U.S. DEPARTMENT OF TRANSPORTATION FEDERAL AVIATION ADMINISTRATION SOUTHWEST REGION

SW 6980.7A

SUBJ: PROVISION OF FILTERS FOR ENGINE GENERATOR CONTROL CABINET VENTS

SW APPENDIX 1. ENGINE GENERATOR CONTROL PANEL FILTER INSTALLATION

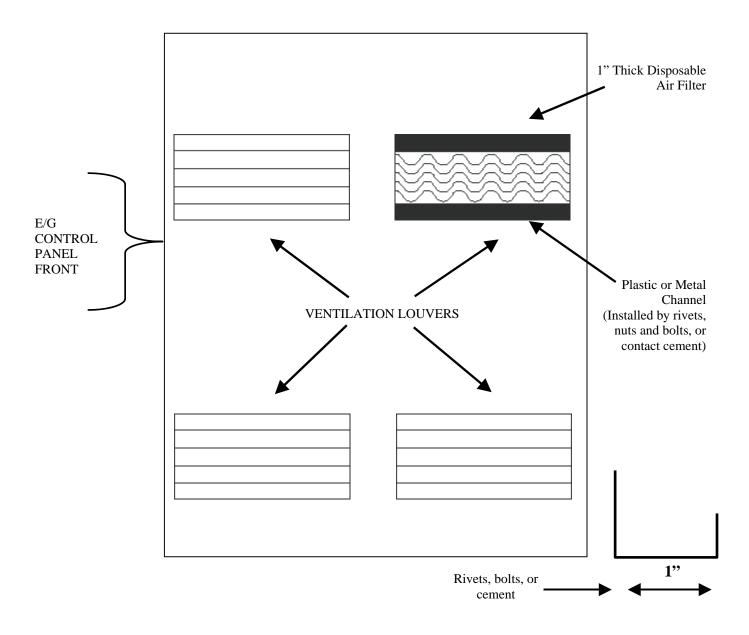
- a. Cut channel to proper length and install according to the drawing shown in Appendix 1.
- b. Install filter in channel.
- 13. CHANGES TO INSTRUCTION BOOKS. None.
- 14. CHANGES TO INSTALLATION DRAWINGS. None.
- 15. CHANGES TO RECORDED DATA. None.
- 16. CHANGES TO TABLE OF CONTENTS. None.
- **17. RECOMMENDATIONS FOR CHANGES.** Forward any recommendations for changes to this directive to the Operations Branch, ASW-470.
